TOWN OF MONUMENT - WATERLINE AND STORAGE TANK
 SITE DEVELOPMENT PLANS
 LOT 6, FOREST VIEW ESTATES FILING NO. 4

90% SUBMITTAL

Site Development Plan _V2 redline.pdf Markup Summary 1-27-2022

2.0M GALLON TANK ELECTRICAL - ONE-LINES

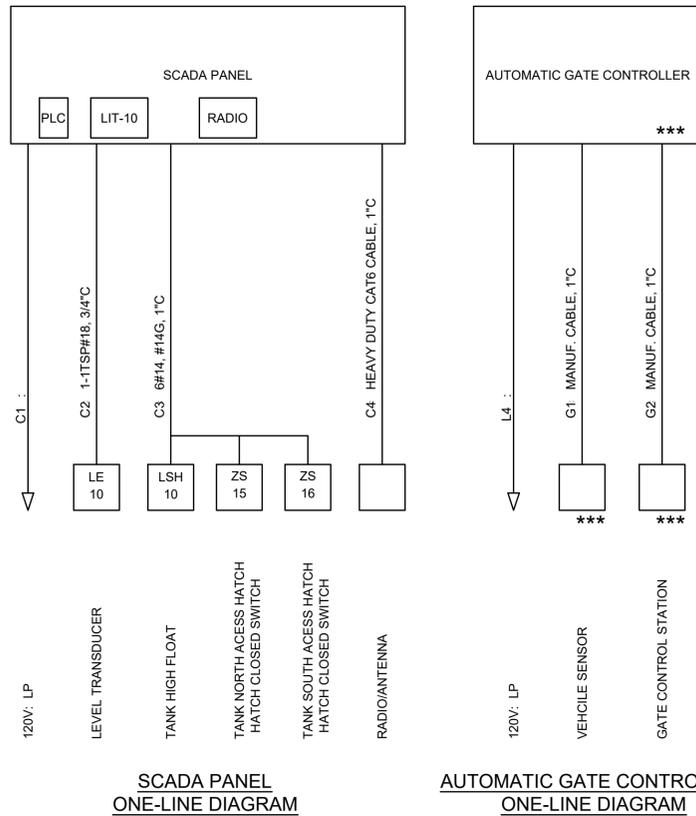
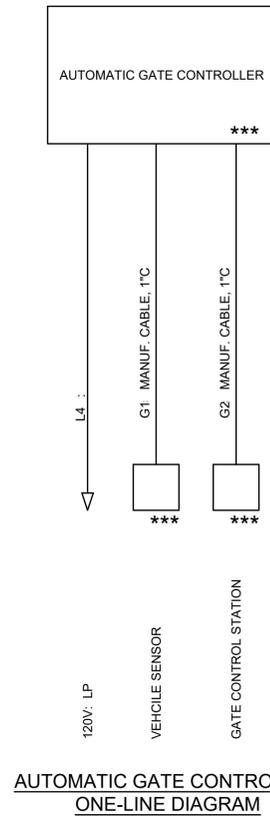
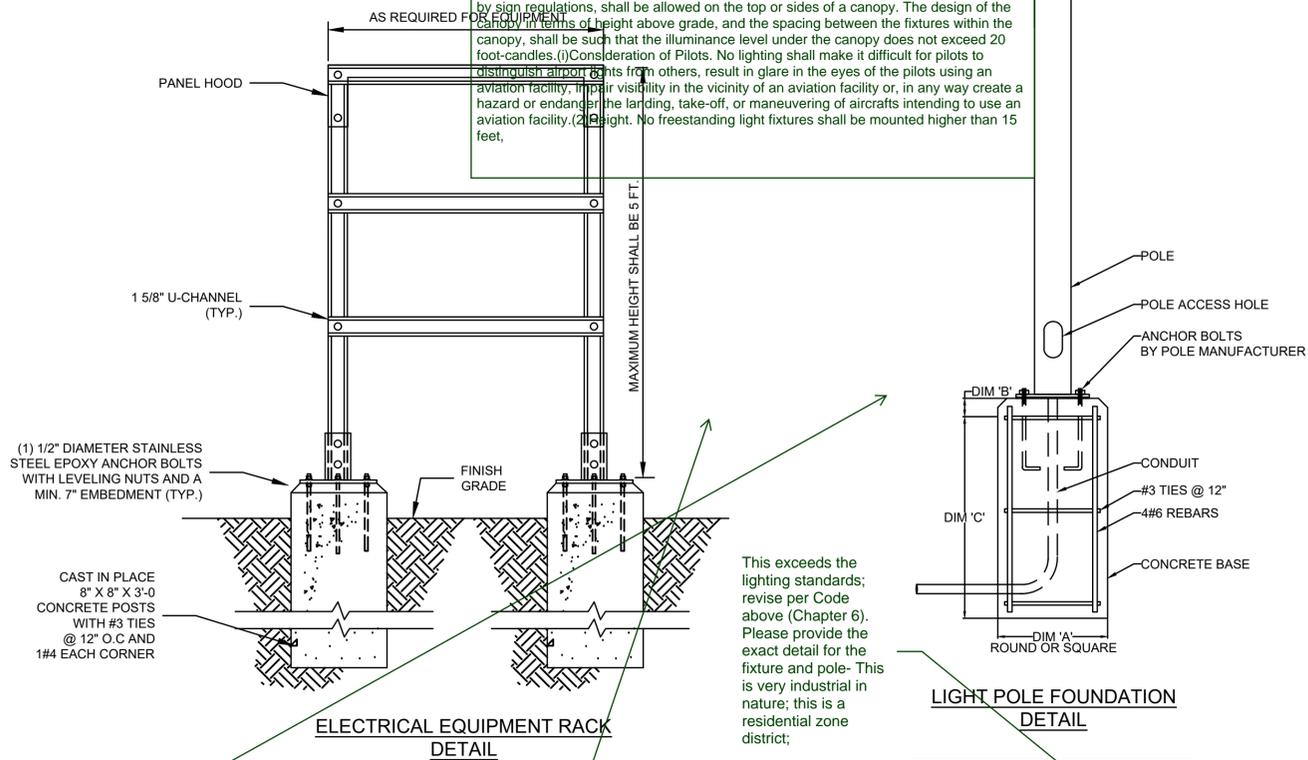
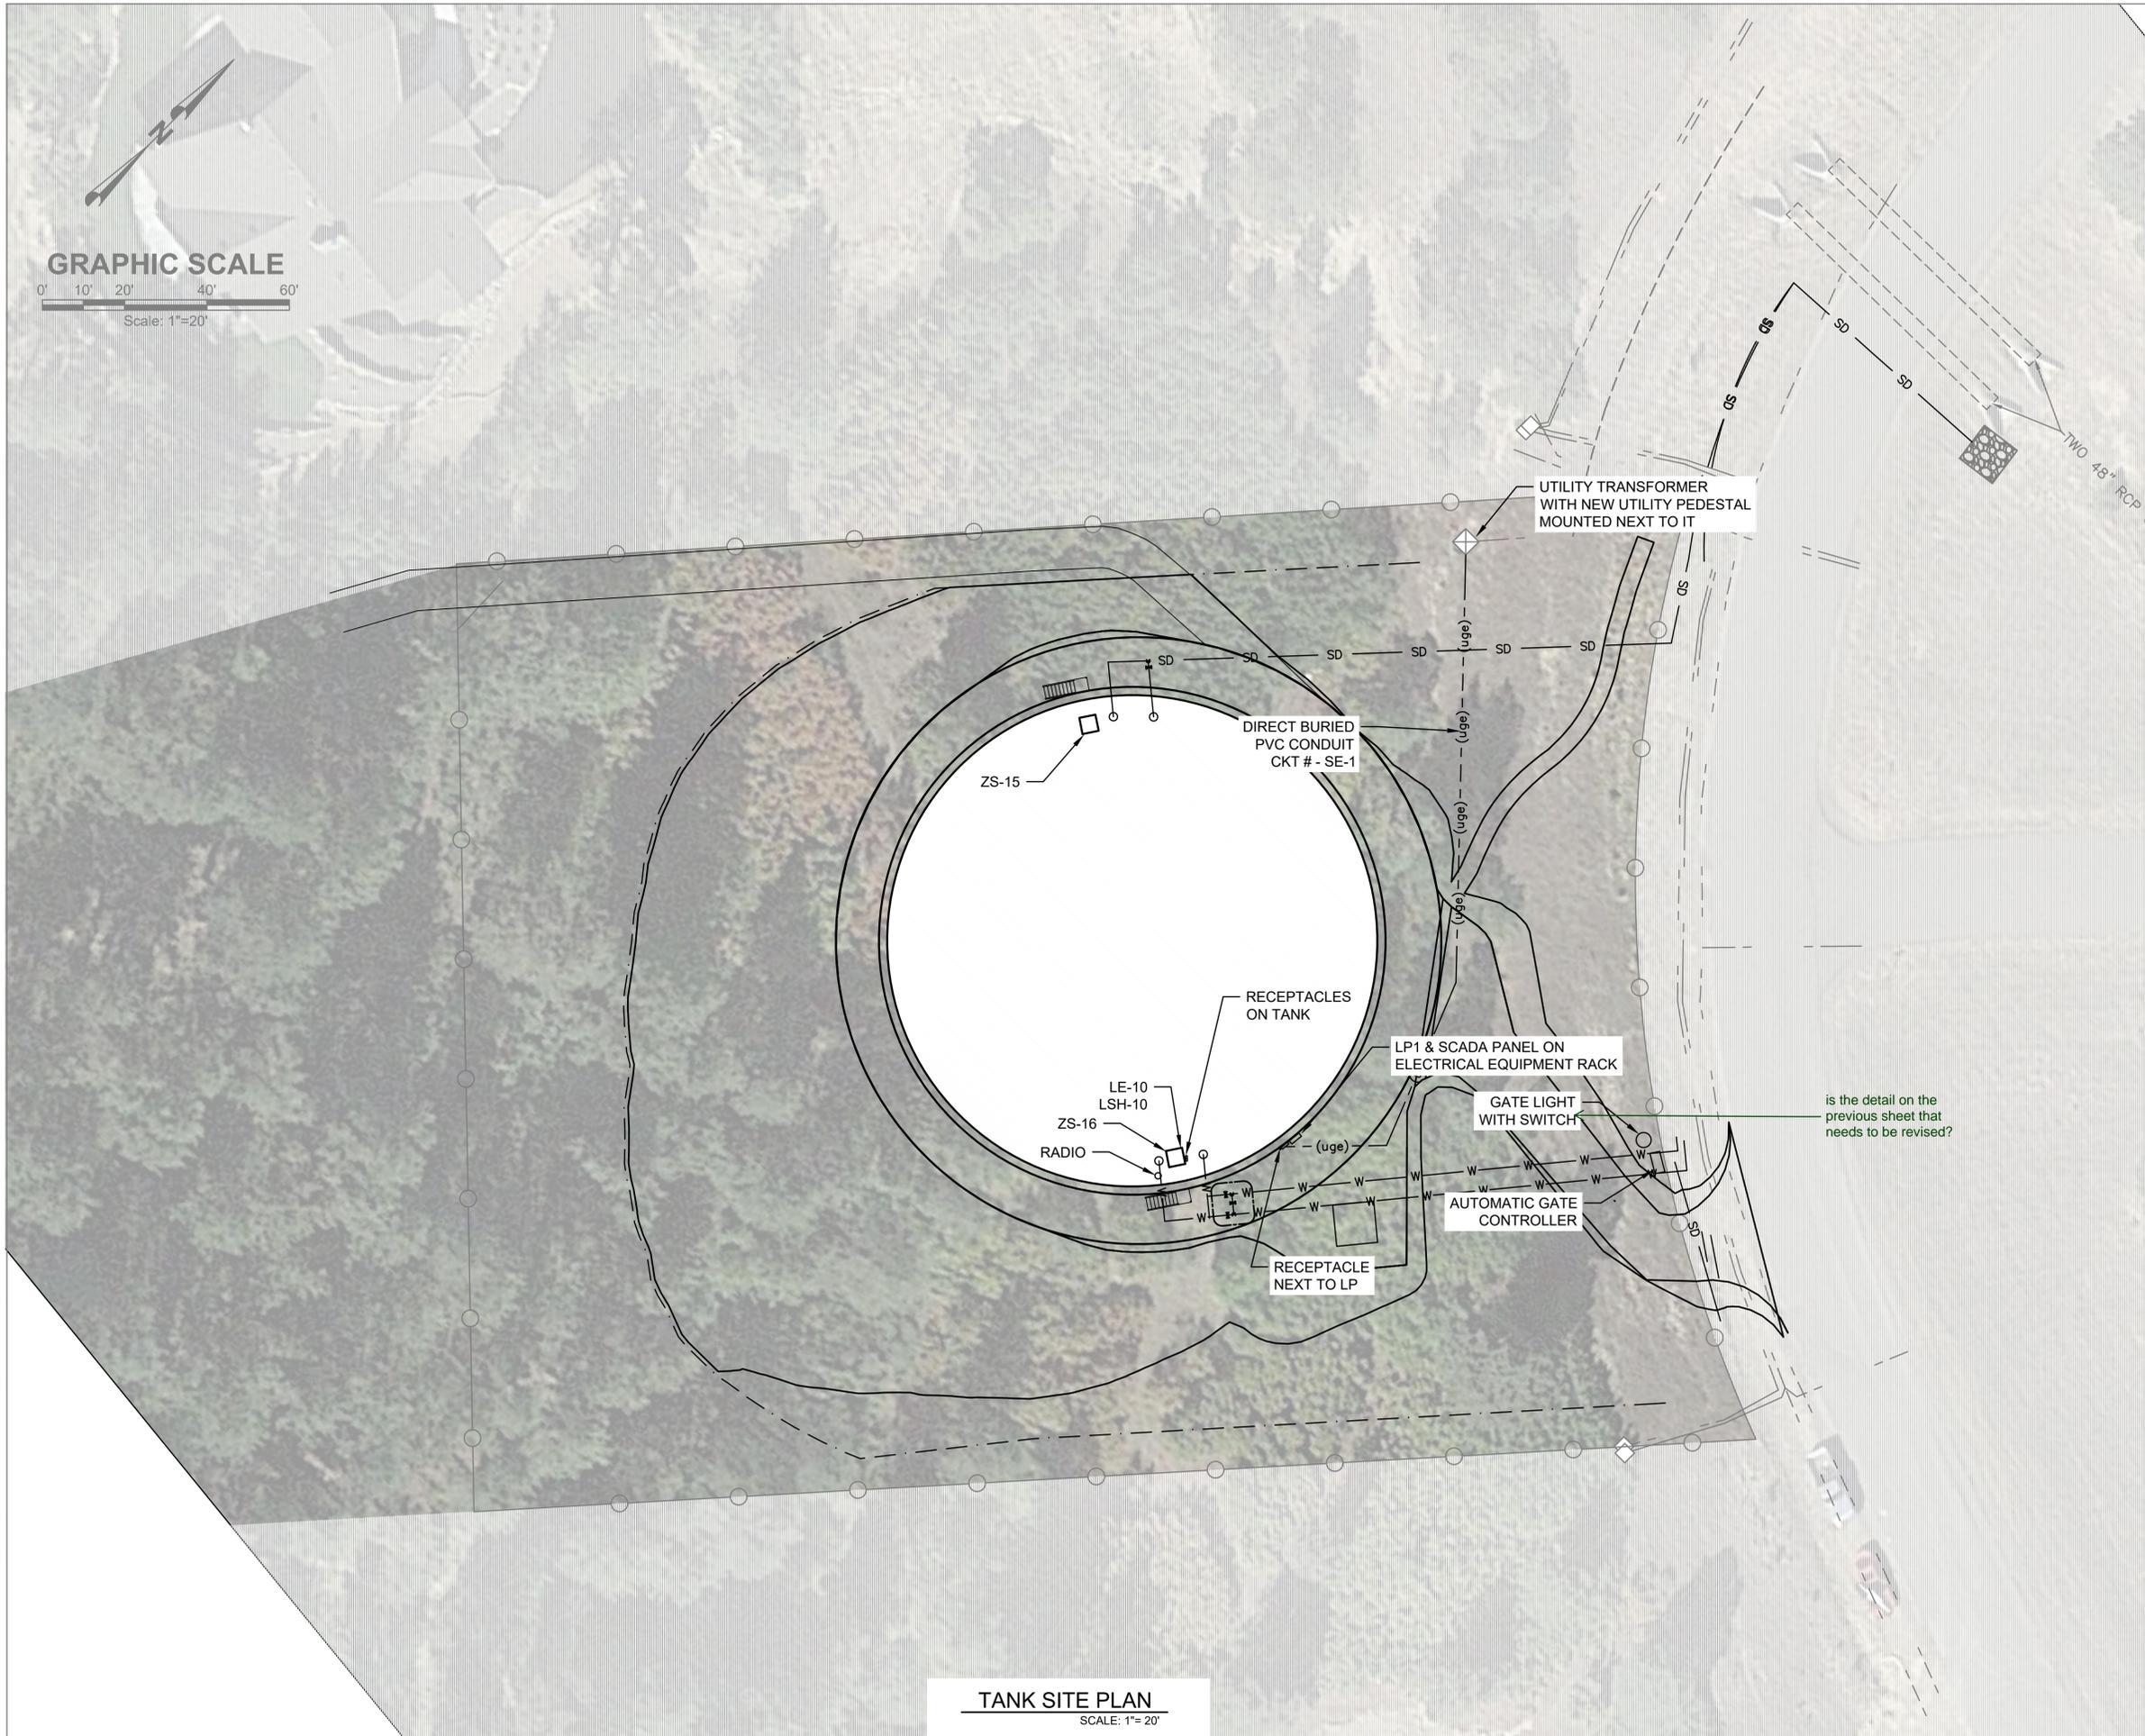
locate light fixtures on this sheet as well as sheet 2

Add note that lumens will not exceed Max (based on Code)

is there only one light on entire project? If not add locations and detail of fixture

This exceeds the lighting standards; revise per Code above (Chapter 6). Please provide the exact detail for the fixture and pole- This is very industrial in nature; this is a residential zone district;
